Spokes objection to RSO/17/13 and TRO/17/81

Leith Street, Calton Road, Greenside Row, Waterloo Place

Referencing: http://www.edinburgh.gov.uk/downloads/download/2391/tro1781_leith_street

and http://www.edinburgh.gov.uk/downloads/download/2392/rso1713_leith_street

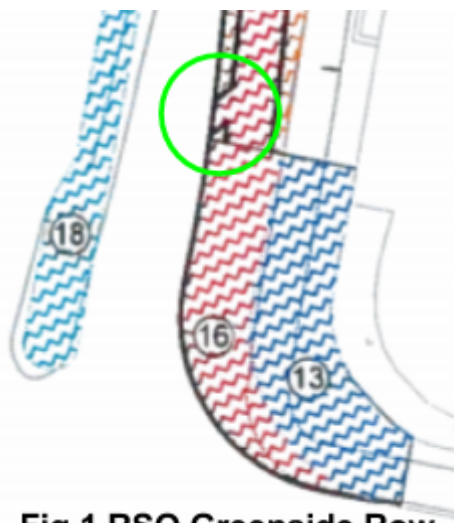
We are disappointed that dedicated provision for cyclists has not been provided up to the East End junction as this is a key route connecting Broughton Street and Leith Walk to the Bridges leading south and used by many cyclists – as demonstrated during the current closure where many journeys are made using the temporary cycleway provided. At the very least a permanent uphill route is required to help cyclists where they are slowest and most vulnerable.

We have discussed this previously with CEC and been told that there is insufficient width to both provide cycle facilities and also to maintain throughput for vehicles. Spokes appreciates that there are limited widths at the top of Leith Street but nonetheless some of this space must be devoted to cycling – a clean, healthy mode of transport for which CEC has tough targets – even if it means reducing throughput for general traffic.

We urge CEC to start developing plans to tackle this section as soon as possible. The status quo where cyclists find themselves squeezed in with other vehicles and often large buses at the top of Leith Street is not tolerable.

Fig 1 RSO Greenside Row

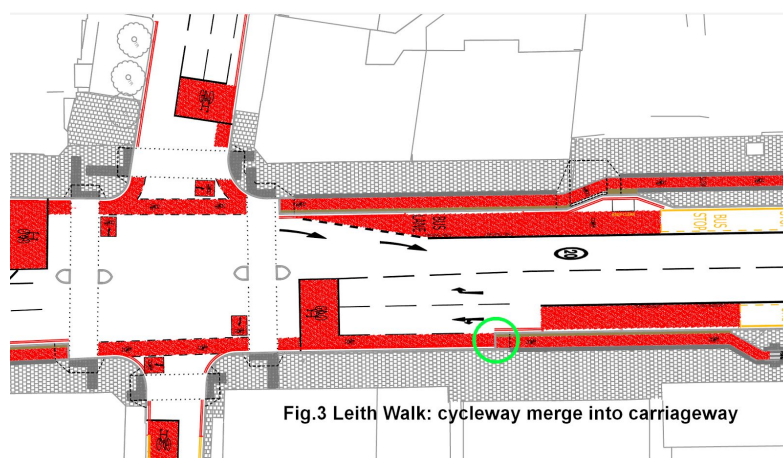
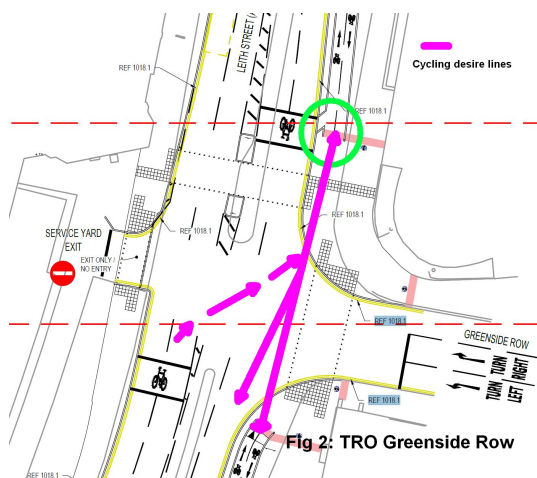
It seems clear from the layout of the southern terminus of the cycleway at Calton Road that cyclists can only join the carriageway onto Calton Road, and not Leith Street. We therefore assume that cyclists wishing to continue up Leith Street to the East End junction will need to use the small section of cycleway just north of the Greenside Row crossing that looks like it will permit rejoining the southbound carriageway (see diagram, left).

We are concerned that this forces cyclists to make a dangerous manoeuvre by merging into traffic without room to do so. We also doubt that there is sufficient space within this small section to accommodate sufficient numbers of cyclists. Inspection of the TRO plans (below left) suggests that there is some space taken up with hatching in the centre of the road that should instead be reallocated to provide a safe zone for merging, as described in *Cycling by Design* §6.2.6 and as used in the recently opened cycleways on Leith Walk, where the cycleway continues straight ahead into a cycle lane on the road (see diag Brunswick Rd). The 500mm buffer zone could also be included in a feed-in lane. We also have concerns about buses pulling out of the lay-by having sufficient forward visibility to see cyclists joining the traffic stream here.

Additionally, it seems likely that cyclists unfamiliar with the layout who are looking to get to the East End junction will assume they can continue on the cycleway across the Greenside Row crossing only to find they are forced onto Calton Road as per the above. Please confirm that appropriate markings/signage will be used to avoid this confusion, though quality cycle routes should be intuitive to follow without the need for signage. A better solution might well be a signalised parallel straight across crossing of Calton Road at the south terminus of the cycleway. A further option might be to mark a cyclist route to guide cyclists to use the Greenside Row Toucan to join the southbound carriageway, with Leith Street southbound road traffic held during the Toucan phase.

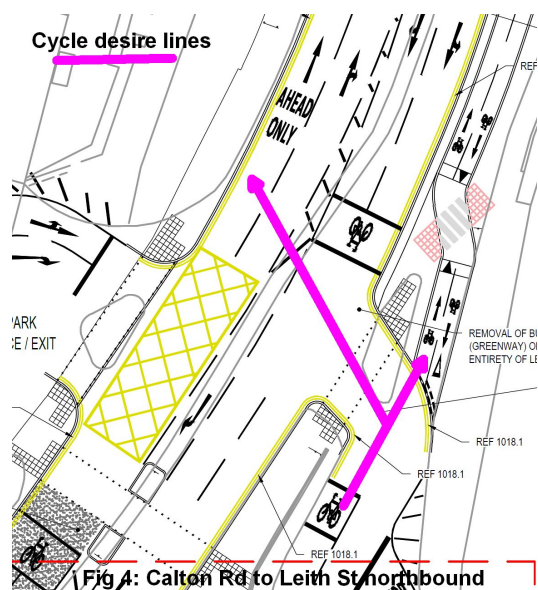
The cycleway at the south side of Greenside Row should be right up to the carriageway as there is no pedestrian crossing of Leith Street on this side, thereby avoiding the need for shared space on the south side

The cycleway on the north side stops a long way short of the Greenside Row crossing, but should be extended at least as far as the east/west pedestrian crossing (or is it a Toucan?) where conflict with pedestrians could be controlled by “give-way” markings as are proposed for the crossing to the small island further north on Leith Street or low-level signals (as at St.Leonard’s Street). Our preferred option would be for the cycleway to continue up to Greenside Row with a parallel crossing marked separately for pedestrians and cyclists. This could also be designed to provide access for southbound cyclists to join the cycleway (as in 2.4/Leith Walk) and for cyclists wishing to proceed to the top (South) of Leith St, to leave the cycleway, with appropriate signalling.

Furthermore, conflict will also be minimised by reducing the corner radii to provide additional space for cyclists and pedestrians, whilst making the junction safer by reducing the speed of turning general traffic. We recognise that there is need for larger vehicles to use Greenside Row for access to the Playhouse and the Omni Centre, but we question whether widths can be reduced further given how much space is available at the junction to allow oversized vehicles to swing out where required.
